**Village of Holmen
Planning Commission Minutes
October 26, 2021**

Possible Action and Recommendation on Proposed Preliminary Plat of Sunrise Addition off Hwy V and Marie Drive

Possible Action on Site Plan & Architectural Review (SPAR) Petition from Erik Craig, Action Plumbing & Heating Corp., for new offices and shop on Granary Street

PRELIMINARY PLAT OF SUNRISE ADDITION A RESIDENTIAL SUBDIVISION

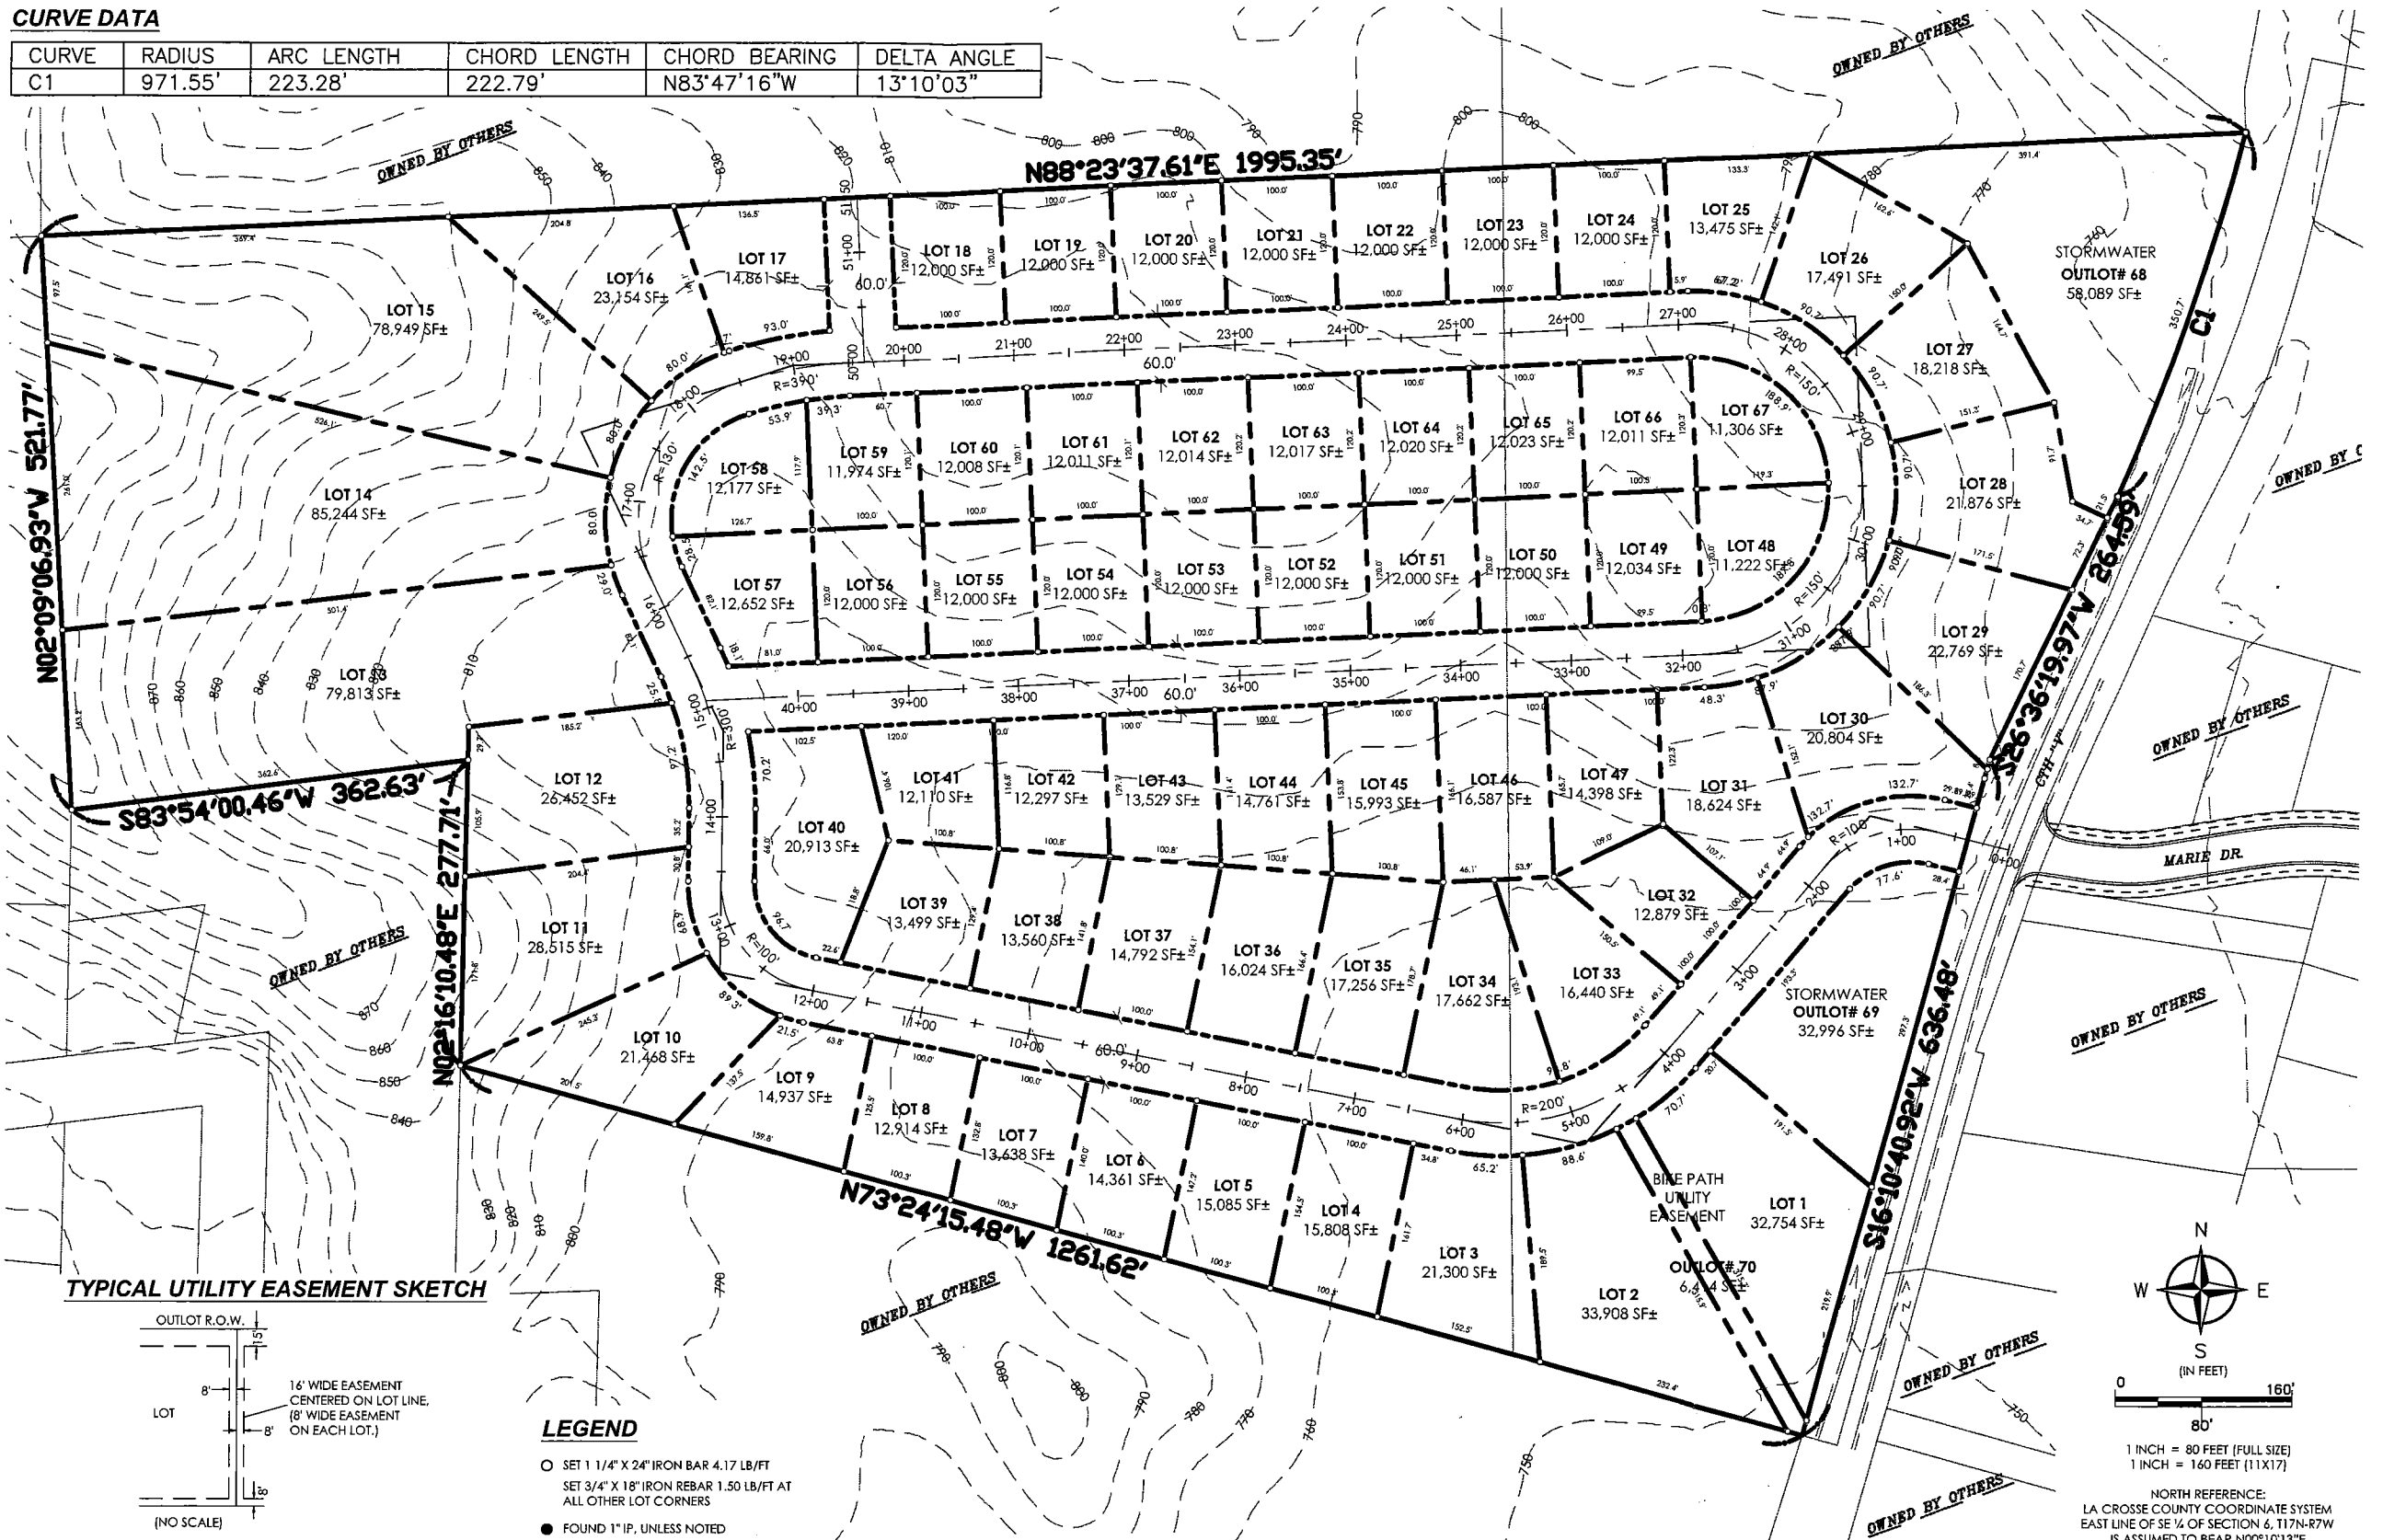
Administrator Heinig stated the proposed development is located along CTH D north of Evergreen Elementary and west of the Evergreen Addition. The access to the subdivision will be located directly across from the Marie Drive/CTH V intersection. The preliminary plat does not have street names which will be provided in the future. There are two storm detention areas laid out on the plat. The northern detention pond will need a storm easement to convey the storm water from the street into the ponding area. The southern detention area may not need a storm easement as the outlot contacts the street right-of-way. There is a utility easement located in the southeast corner of the plat this will also serve as the pedestrian pathway to the school. Administrator Heinig stated there are no parklands dedicated with this plat. Instead of a land dedication the developer will make a monetary donation approximately equivalent to 2 acres of land. He also stated that the lots 57, 58, 48, & 67 are too small as they are corner lots and subject to multiple 25' setbacks. He stated that the remaining lots on that block could be reduced to 95' widths to provide the needed area to the corner lots. He pointed out the possible connection from reservoir 4 to the west. That connection would begin at the end of Hillcrest Drive and be directionally bored through the ridge to the west boundary of the plat. An easement would be needed on the northern 30' of lot 13 to bring the watermain into the street. The dimensions of Lot 12 would be modified to replace the lost frontage on lot 13. He stated there is a road out the north boundary for future connection into the Lee Farm when that is developed. He pointed

out the fire department has stated this is a long dead end and access would be restricted if there were a fire response. This would be temporary as the future connection into the Lee Farm would provide a second access.

Member Barlow stated his concern with the hilly terrain and runoff potential to overwhelm the downstream system. Administrator Heinig stated that the engineering hasn't been submitted. When that information is reviewed the size of the outlots may be adjusted accordingly. Engineer Dahl stated that the existing run-off pattern is generally divided along the new access. The runoff to the south of the new intersection goes into the CTH V storm sewer and runoff to the north of the intersection heads into the large drainage ditch between the development and the cemetery. It is too early to say how the development will change that pattern, or how much area each storm pond will handle but the downstream capacity of the CTH V storm system will be looked at carefully.

Motion by Stanek, seconded by Kertis to approve the Proposed Preliminary Plat of Sunrise Addition off Hwy V and Marie Drive contingent on the revisions to required easements, the lot sizes specified and final storm water/utility engineering. Carried 5-0.

WEST ELEVATION
SCALE: 1/16" = 1'-0"

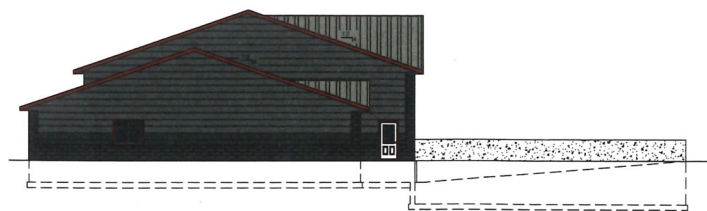
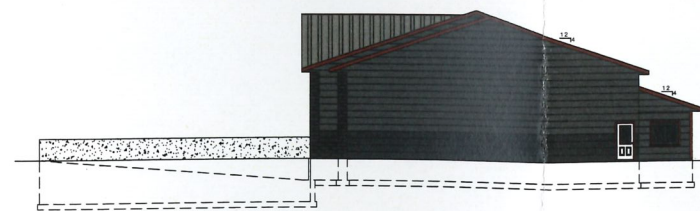
Member Stanek asked if the shakes should be required on the east and west building faces. Administrator Heinig stated he felt this would soften the building lines.

Motion by Grokowsky, seconded by Kertis to approve the Site Plan & Architectural Review (SPAR) Petition from Erik Craig, Action Plumbing & Heating Corp., for new offices and shop on Granary Street contingent on the addition of the shakes to the east and west building faces. Finding that the purposes and guidelines of the SPAR Ordinance have been reasonably met, regarding the entire proposed site plan, all external building colors and materials, overall building layout and design, site and building lighting, site and building signage, and site landscaping. Carried 5-0.
